## HERITAGE COUNCIL OF NSW – GENERAL TERMS OF APPROVAL INTEGRATED DEVELOPMENT APPLICATION

**Address:** Oran Park  
**SHR item:** Oran Park (SHR No. 01695)  
**Proposal:** Approval for site-specific development standards for building height on 66 residential allotments and erection of three (3) new dwellings on three (3) lots subject to this Concept DA.

**IDA application no:** IDA/2021/14, received 8 February 2021

3D Envelope  
1:100

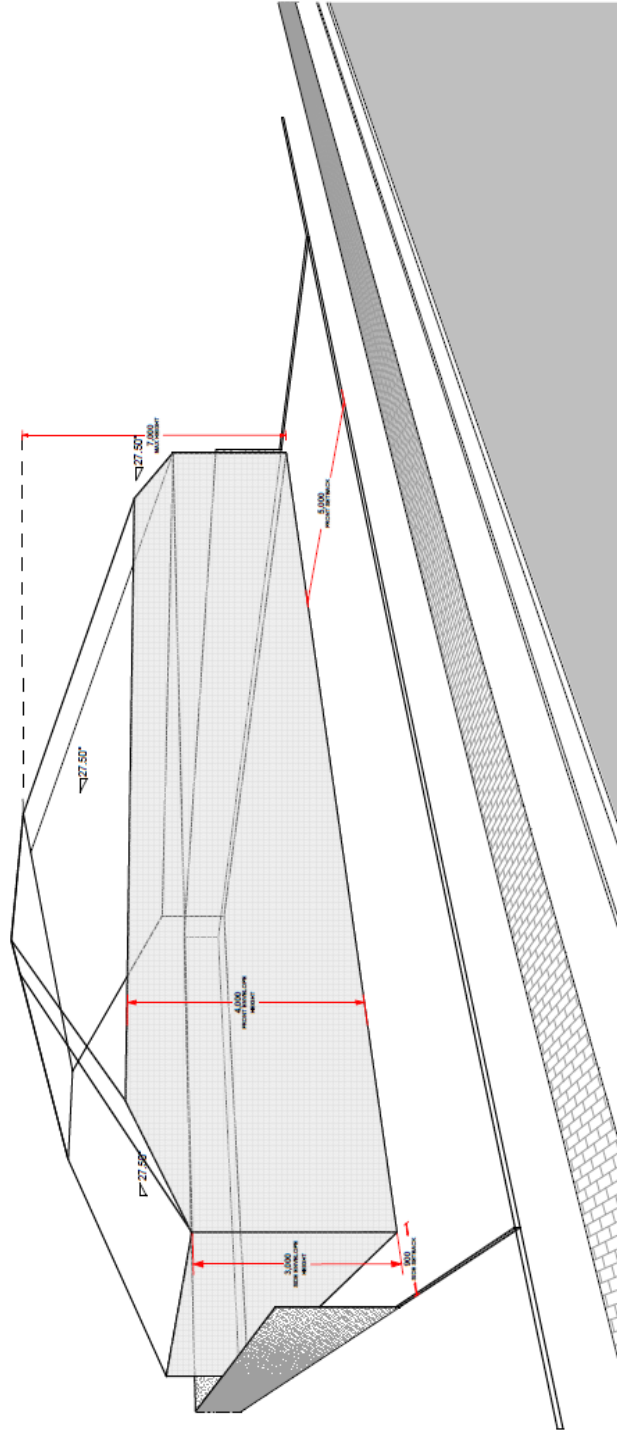
2. The proposal shall be amended in accordance with the attached drawing (see below):
  - 4m height limit at the front building line to a maximum of 30% of the building frontage;
  - Building height envelope which increases by 27.5 degrees from the building line to a maximum 7m height;
  - The 7m height limit at the rear ridge height includes the approximately 0.4m building base; and
  - New houses should not include dormer windows or skylights in roof spaces (except on corner lots, as outlined in the site-specific exemptions).

*Reason: To minimise impacts upon views and setting to and from the Oran Park heritage curtilage. Please note that all other controls including the DCP and Guidelines remain unchanged including the need for them to be single storey.*
